**Response to An Bord
Pleanála's Opinion
ABP-308945-20**

Coolagad SHD

March 2022

This report accompanies a Strategic Housing Development (SHD) application to An Bord Pleanála under the Planning and Development (Housing) and Residential Tenancies Act, 2016 on lands c.26.03 ha at Coolagad, Greystones, Co. Wicklow. It also addresses the additional documentation requested by An Bord Pleanála.

Figure 6: Extract from Contextual Site Section Y-Y (PL0501) showing the relationship with Waverly at the pre-application stage

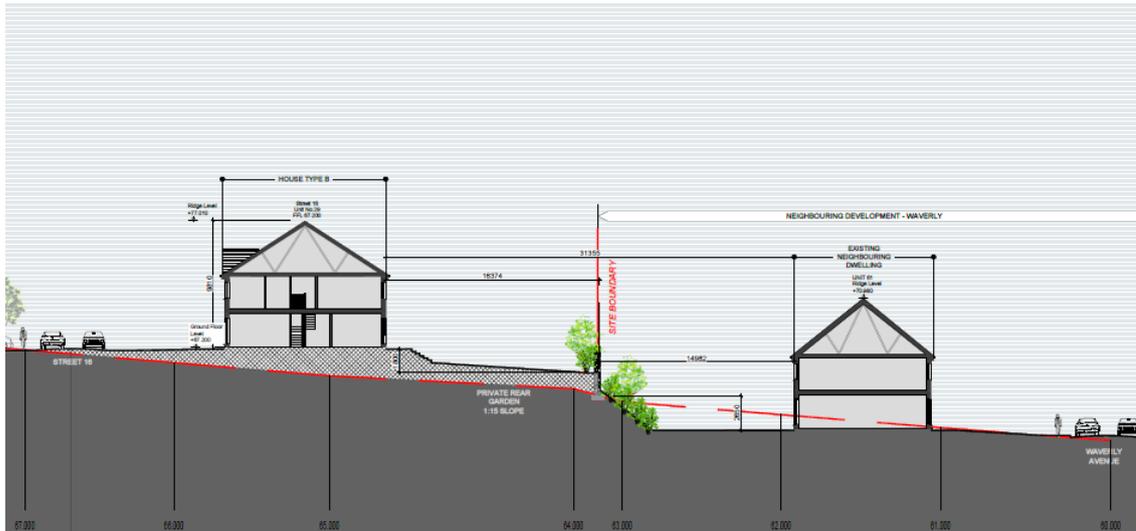
*b) the potential negative impact on residential amenities, in terms of **overlooking, overshadowing or overbearing** impact, due to the topography of the site and the potential requirement for **retaining features**.*

It was envisaged that 607 units would be proposed to include a row of houses to the west of Waverly. This would have required a substantial cut and fill exercise which would have given rise to a number of environmental issues, particularly in relation to soils. Houses at the location would have required the provision of retaining structures between the application site and Waverly which, in turn, could have given rise to concerns of impact on the residential amenities of Waverly.

As the site falls steeply west to east, the development strategy evolved owing to a cut-fill rebalancing of the profile of the site. Had the eastern strip been developed, the quantum of soils to be moved would have significantly greater and would have resulted in the provision of retaining structures between Waverly and Coolagad.

Figure 8: Extracts from Landscape Sections III

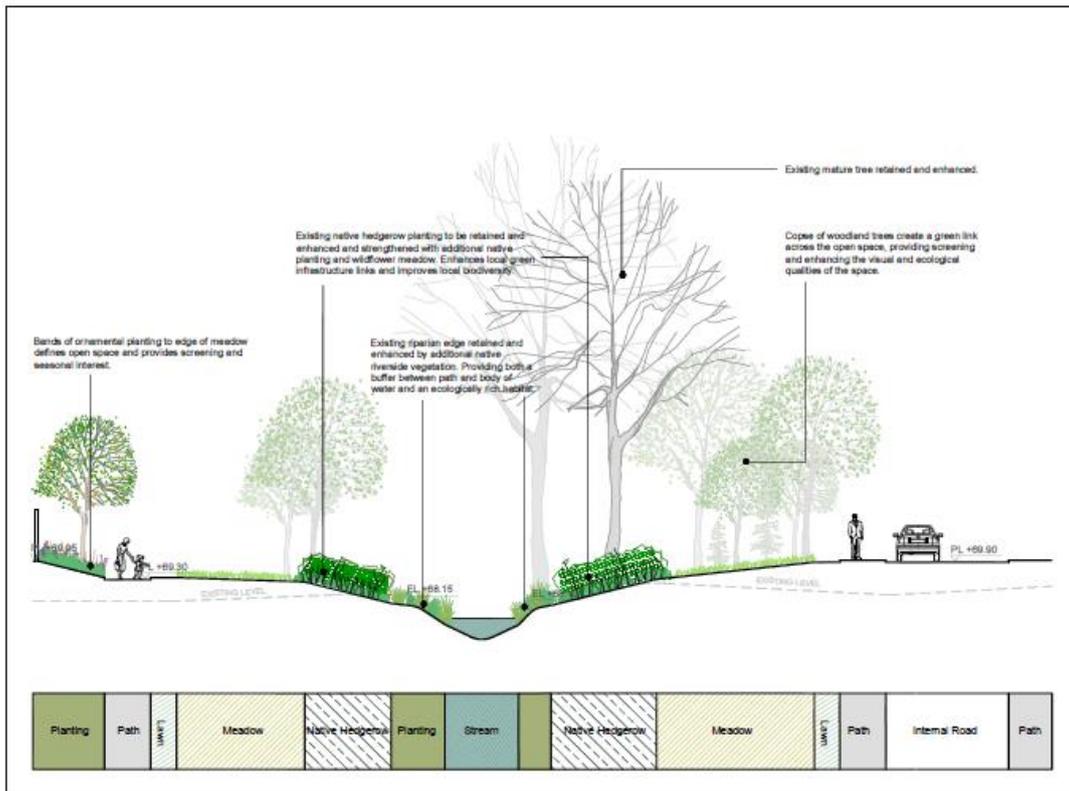
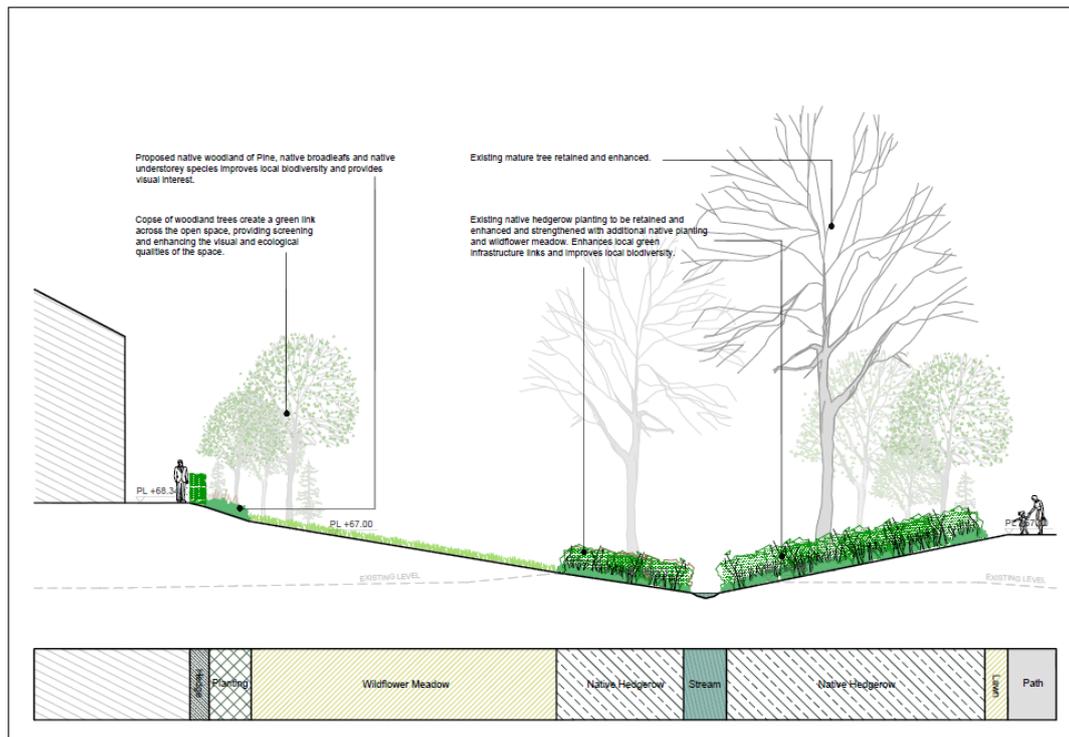
e) the location of existing watercourses on the site which currently run off to a culvert with limited capacity.

As there is a stream crossing the site in an east-west manner, the design had no option but to cross it to allow for access to the southern section of the landholding. The team was cognisant of requirements to a) apply a buffer in accordance with the CDP and b) avoid in-stream works. As a result of the design amendments discussed above, two crossings are proposed. No instream works are proposed.

The design of the stream crossings (bridges) consists of pre-fabricated structures which reduces the risk of any direct impact to water quality in the stream as can be seen in Engineering drawings no. 1701 – Structure ST01 General Arrangement and no.1702 Structure ST02 General Arrangement. We also refer the Board to the EIAR Chapter on water which considers impacts to the stream.

We also refer the Board to Section J-J and Section K-K (both on landscape drawing 103 – Landscape Sections III) which shows the relationship between the development and the stream.
